**STATUS OF FEMP WASTEWATER TREATMENT UNITS AS SWMUS OR
HWMUS**

**C:OP:93-0737
DOE-FN/FERMCO OEPA
20
LETTER**

**FINAL REPORT ON THE APPLICATION OF THE MIXTURE RULE EXCLUSION TO WASTEWATERS
MANAGED IN THE FEMP WASTEWATER TREATMENT SYSTEM**

ENCLOSURE 2
RESPONSE TO SPECIFIC OEPA COMMENTS ON THE DRAFT REPORT ON FEMP'S WWTs

Attachment 1
Block Flow Diagrams for the FEMP Wastewater Treatment System
(1980 to 1990)

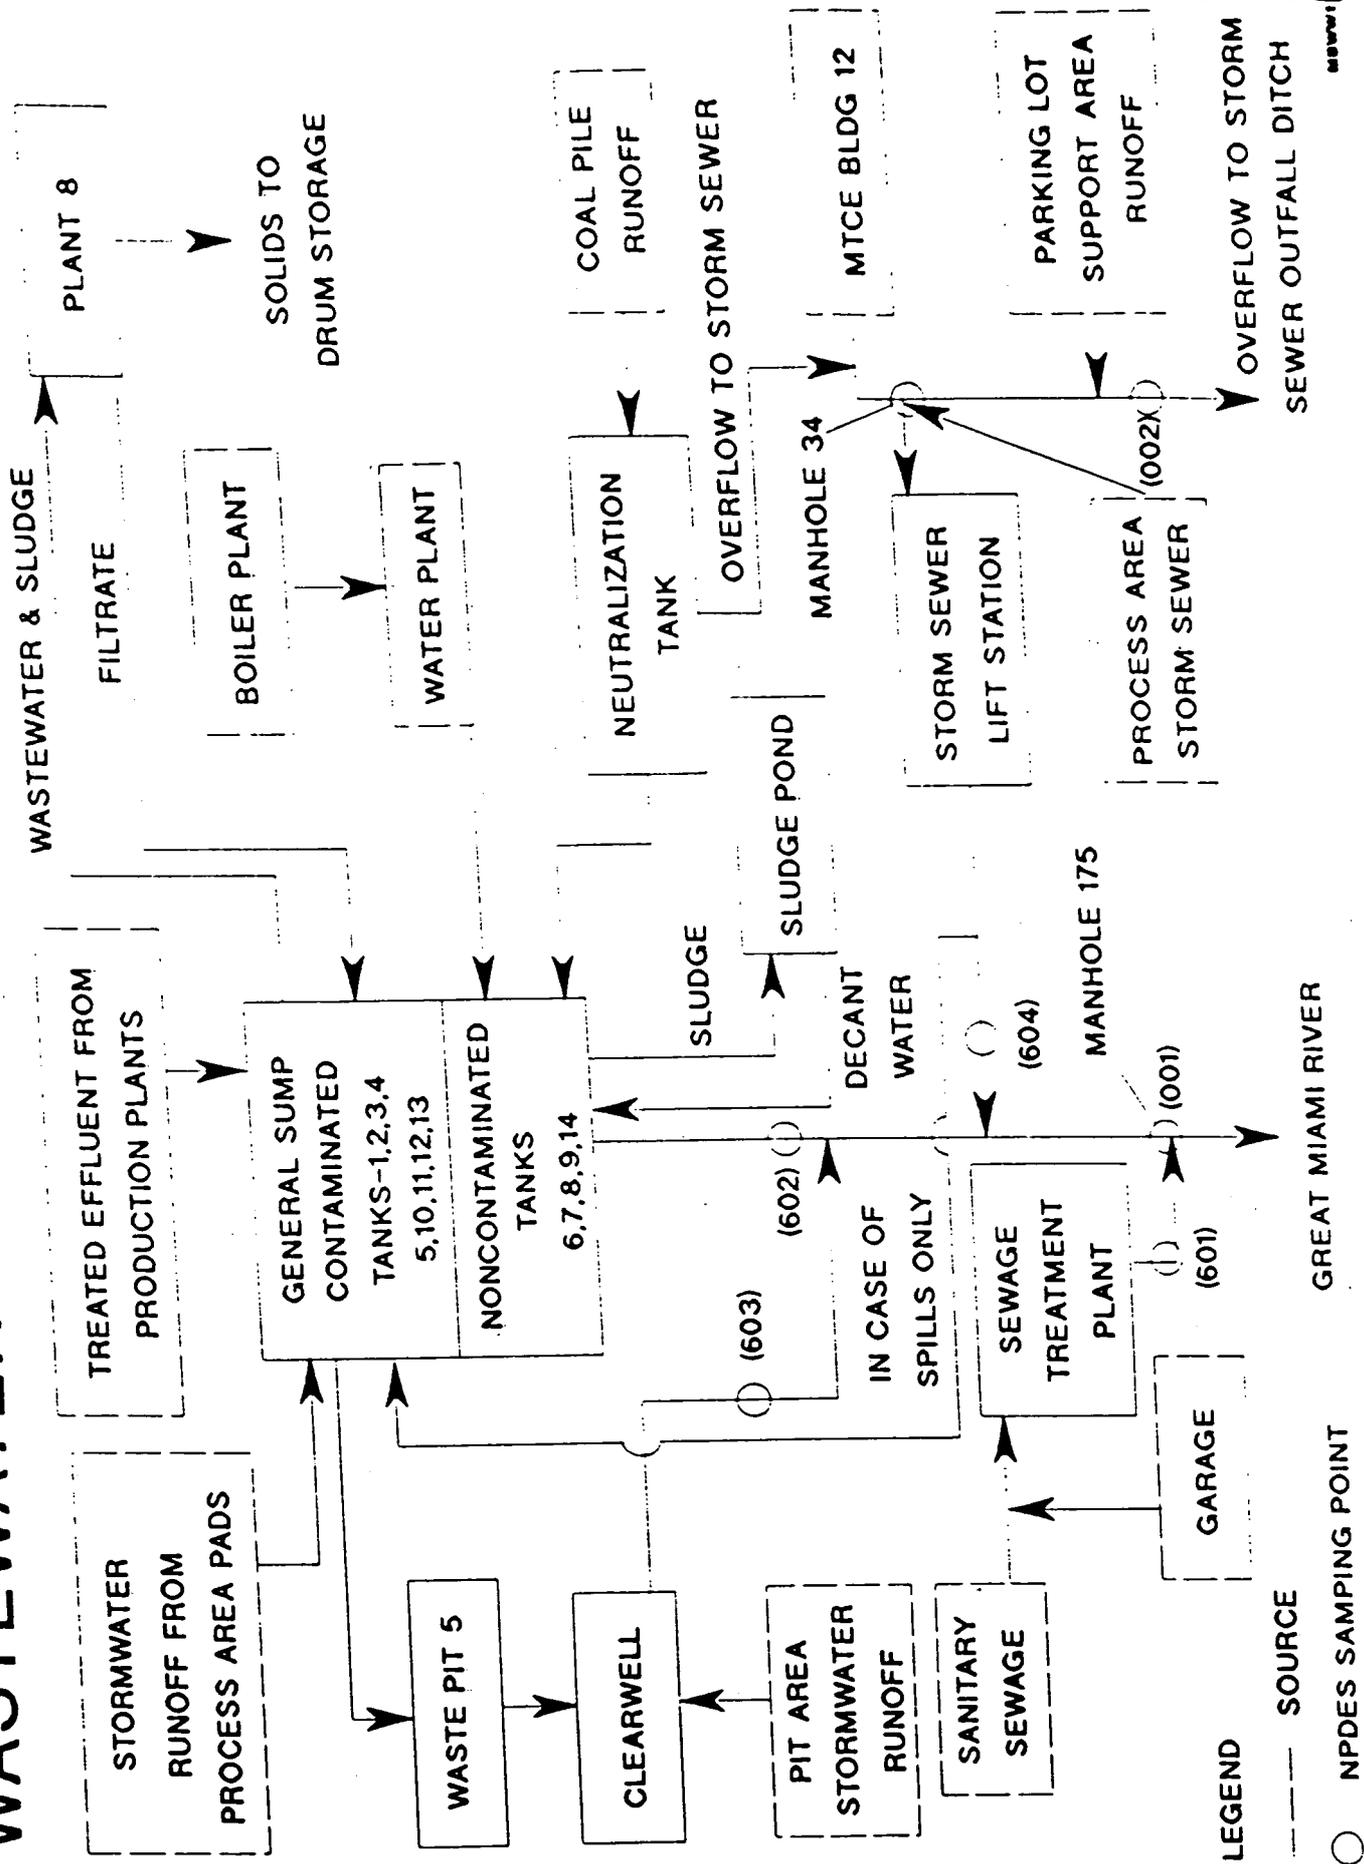
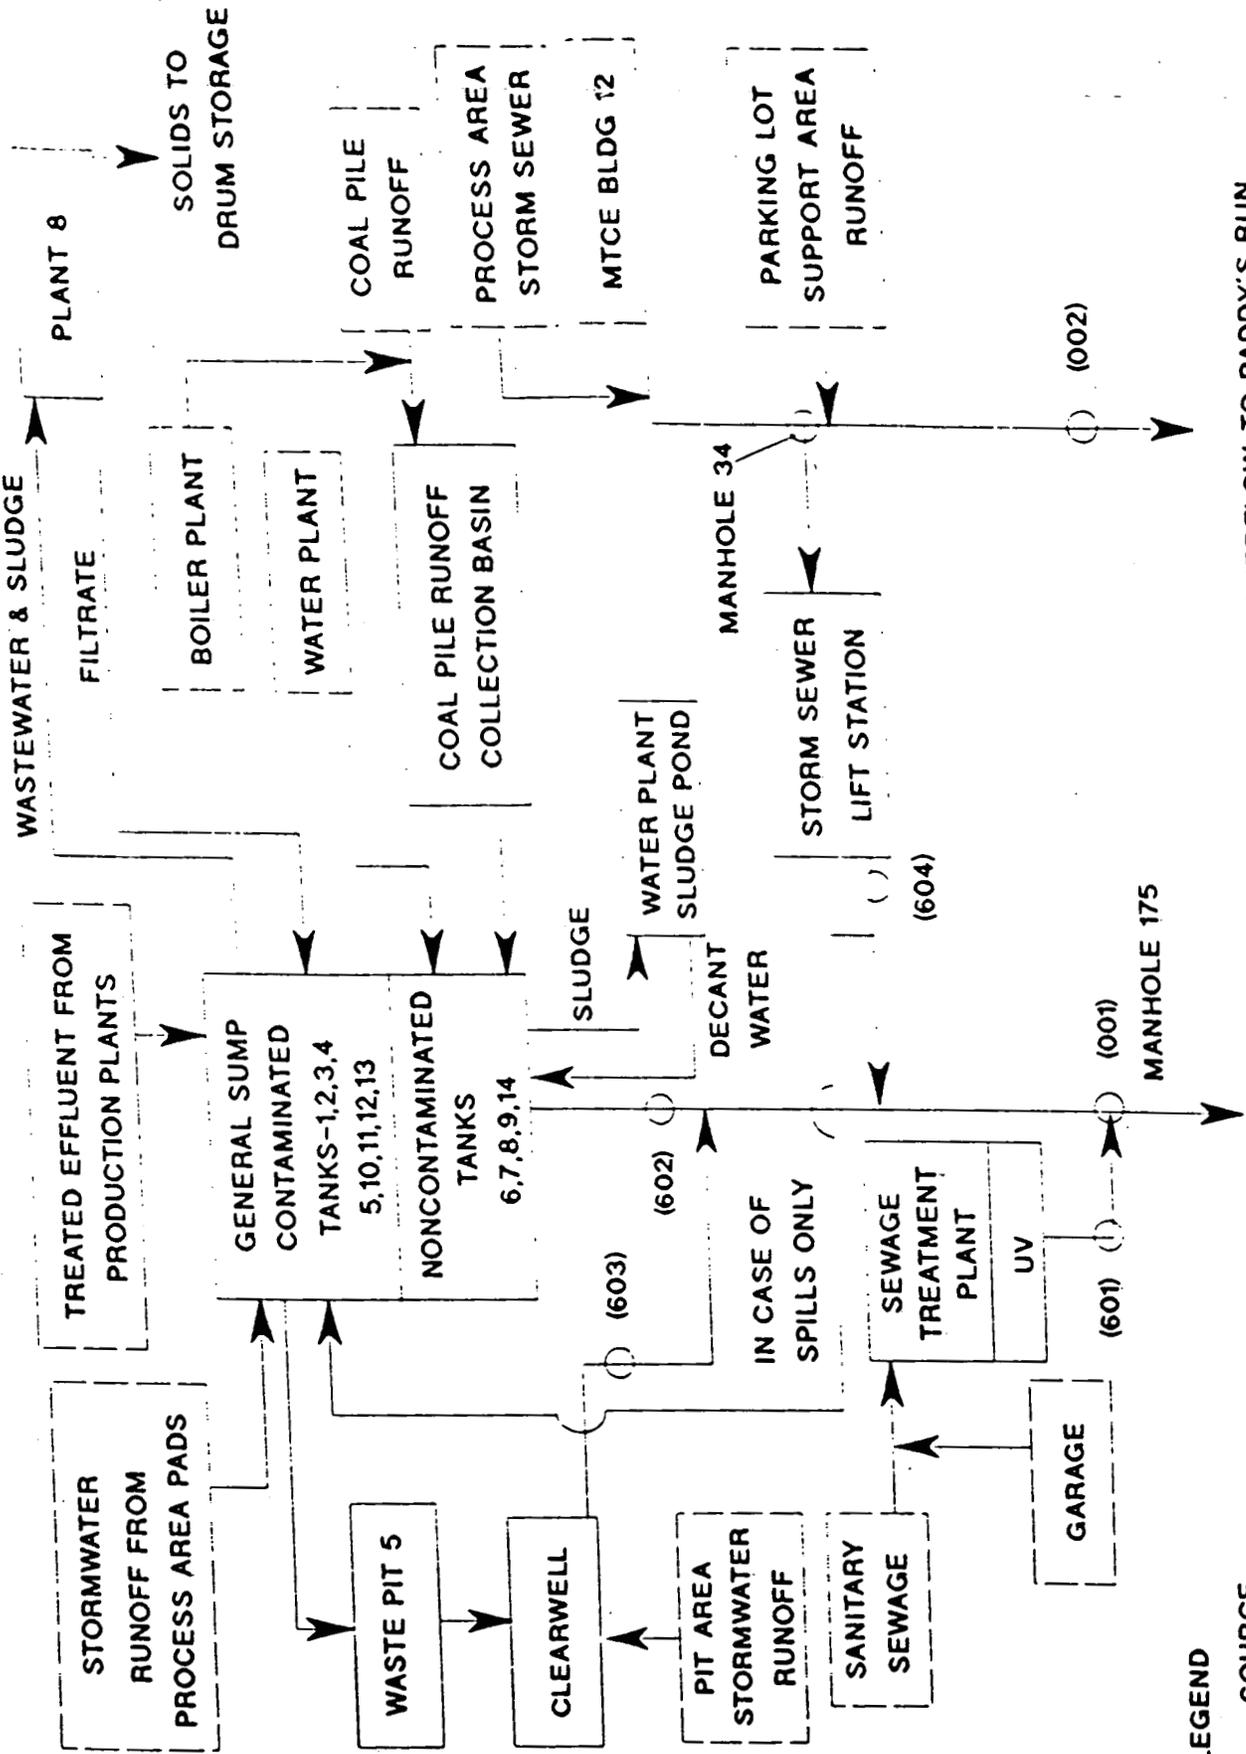
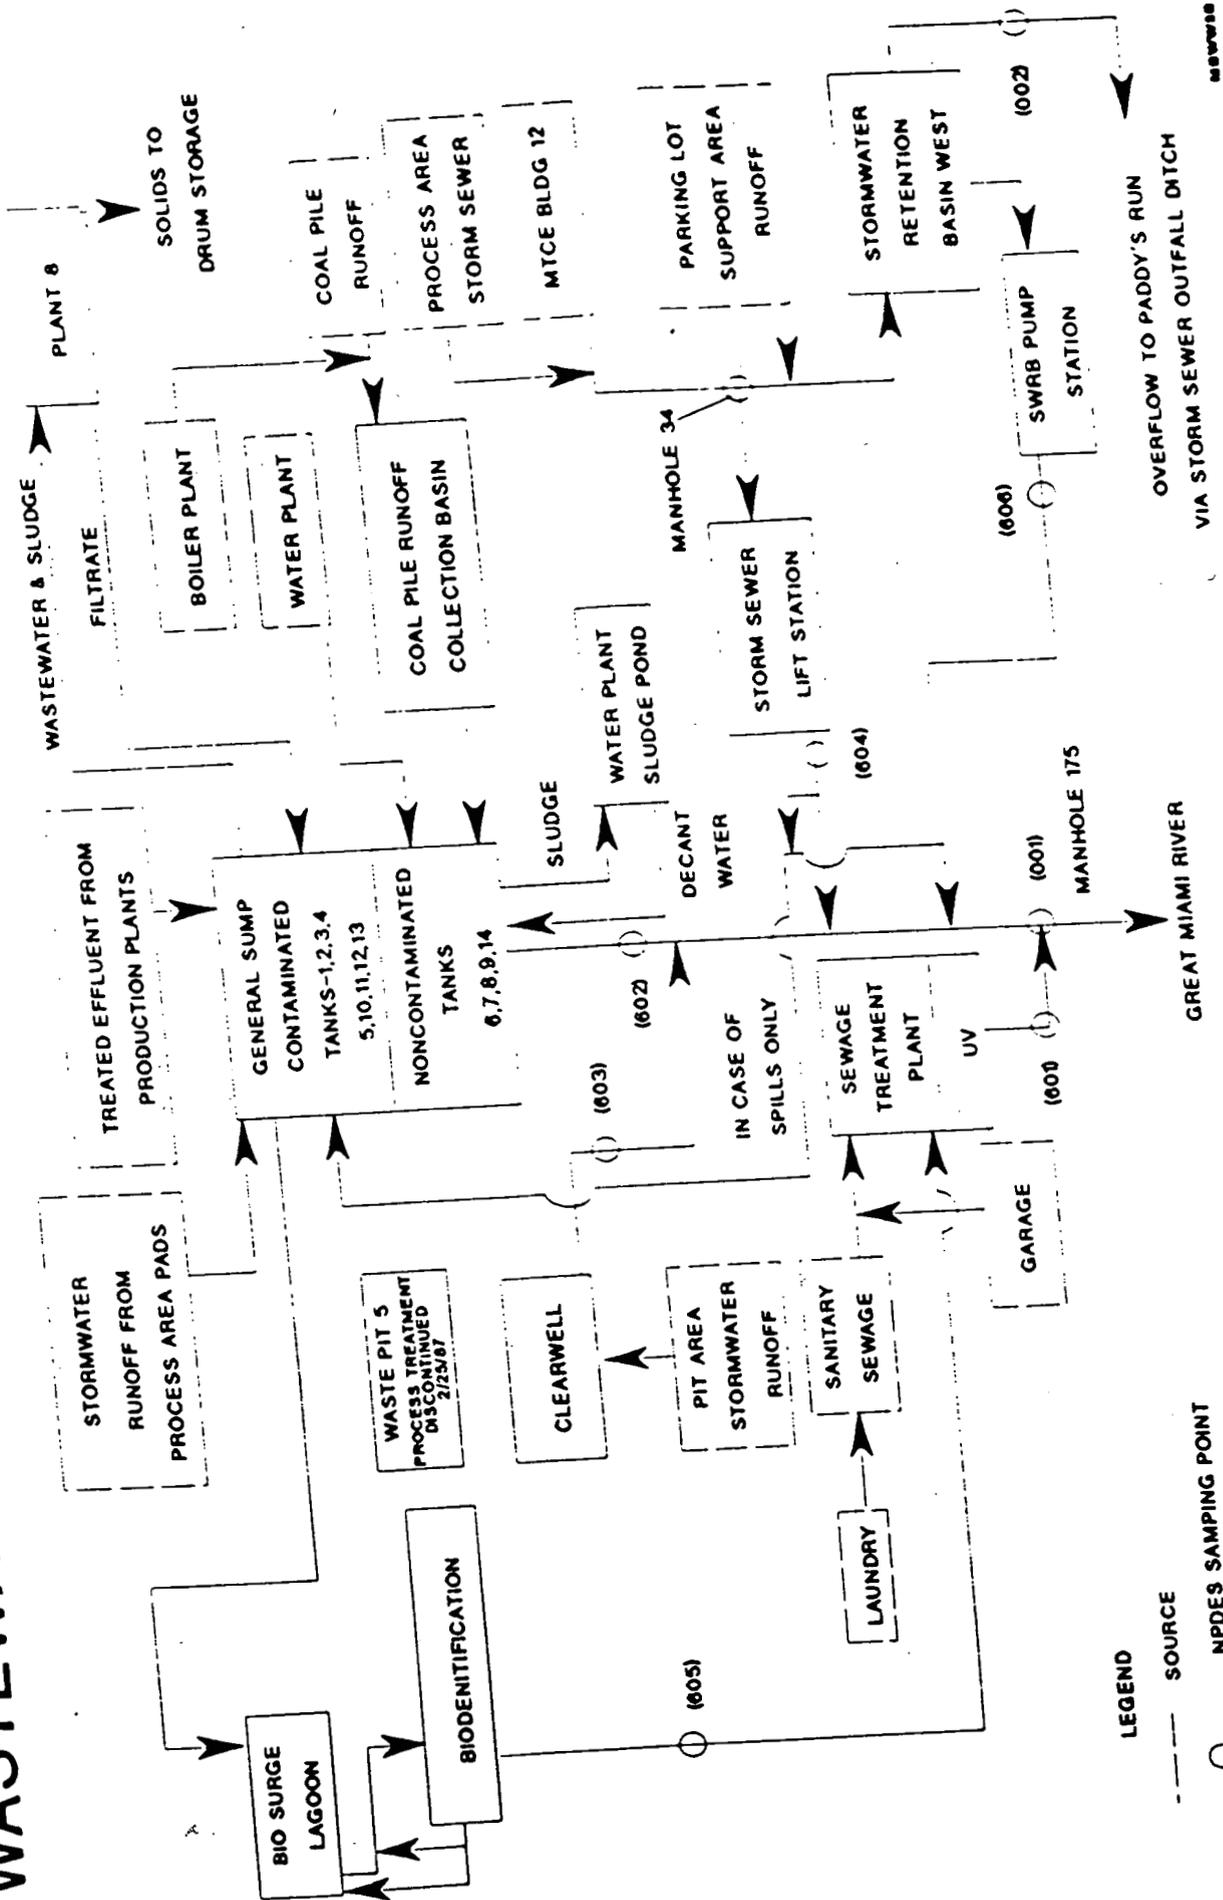
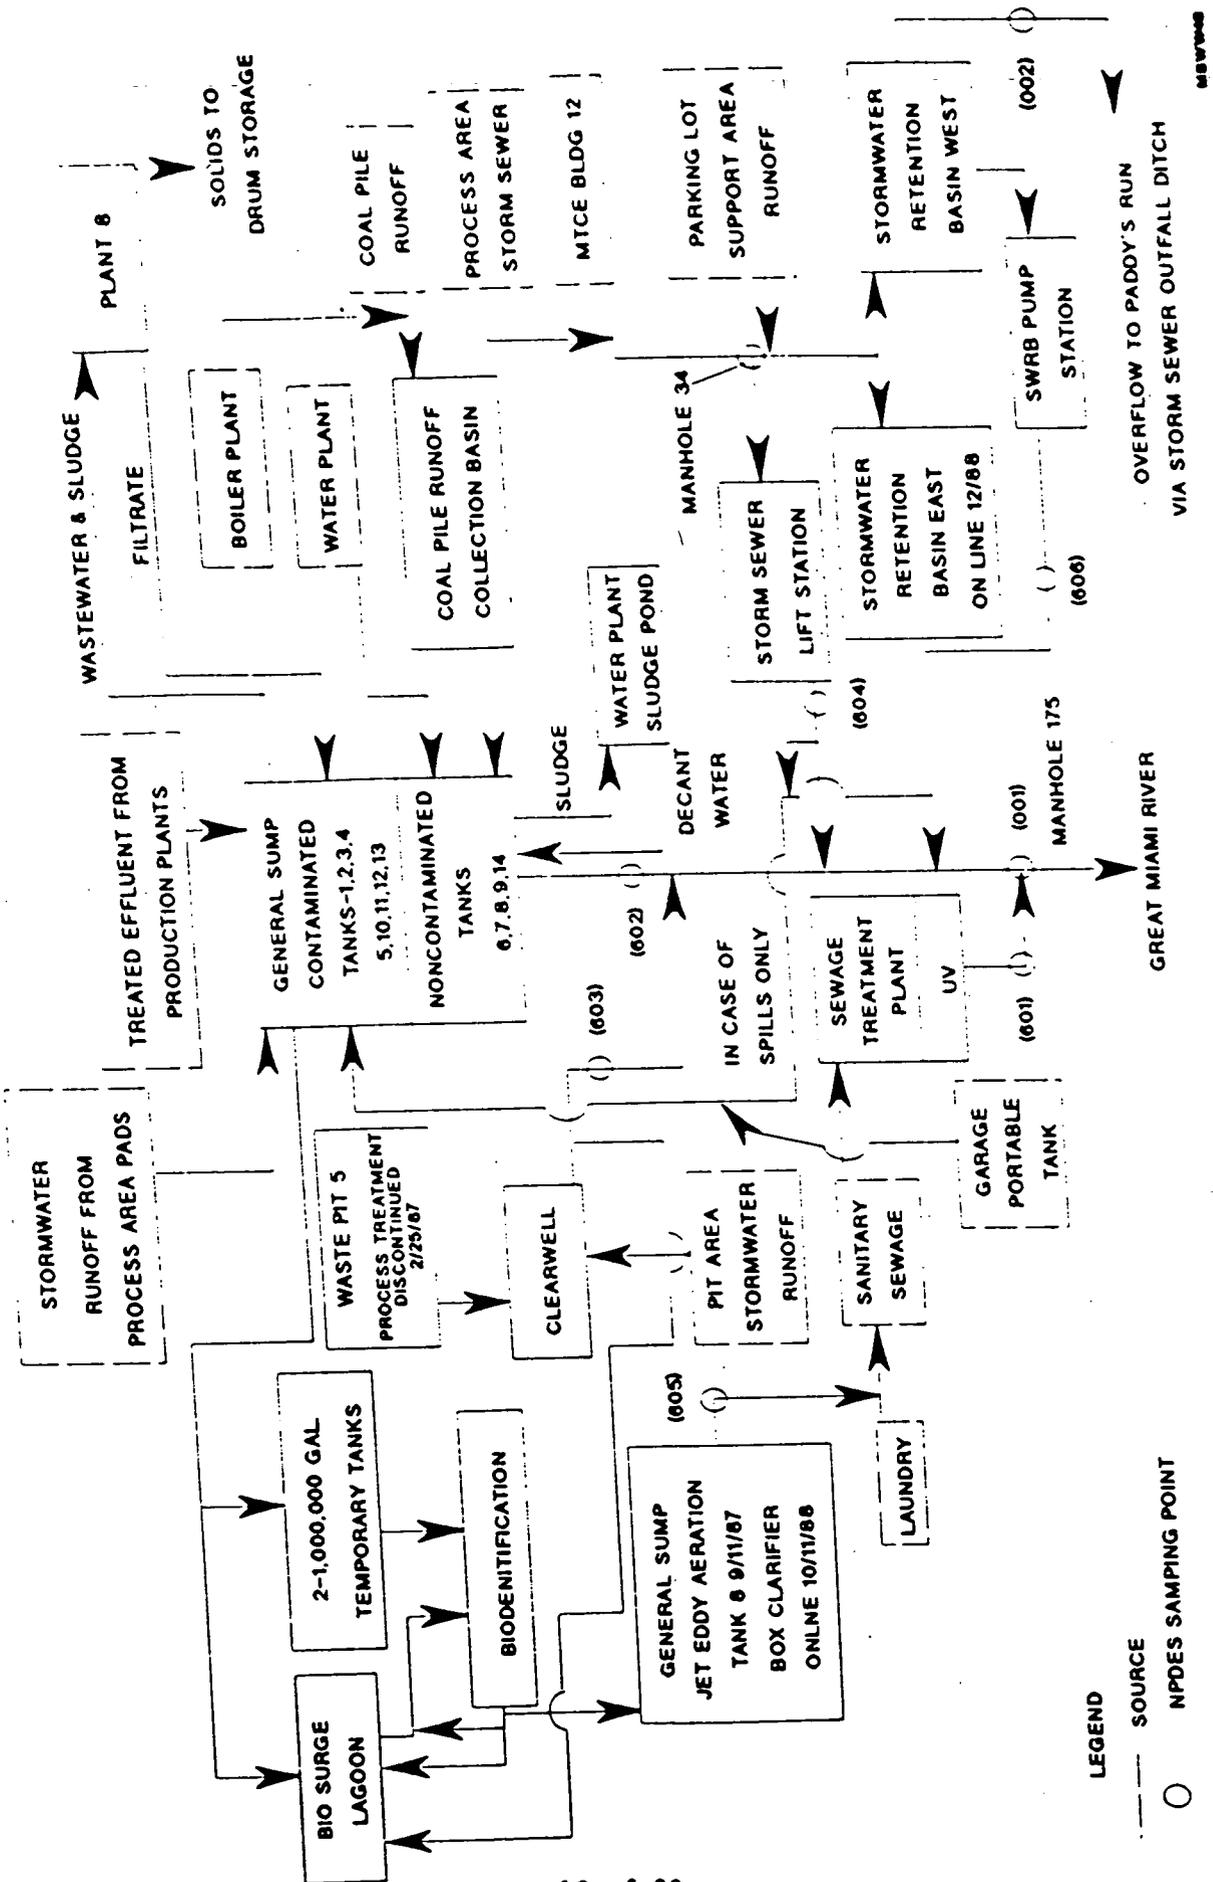
1. *Ohio EPA requests all documentation which exists to support the numbers used for wastewater flow in the 9/5/91 report for the NGS headworks calculations. Indicate any and all locations at which this flow was measured.*

The final wastewater mixture rule exclusion report uses the National Pollutant Discharge Elimination System (NPDES) Discharge Monitoring Report (DMR) data for all flows used in the calculations. The NPDES permit requires flow measurement at the final outfall 001 and the internal outfalls:

- Sanitary System - Sampling Point 601
- Noncontaminated General Sump - Sampling Point 602
- Contaminated General Sump - Sampling Point 603 (prior to 1987)
- Stormwater System - Sampling Point 604

The block flow diagrams in Attachment 1 show the location of these sampling points. A summary of the data is provided in Table 4 of the report.
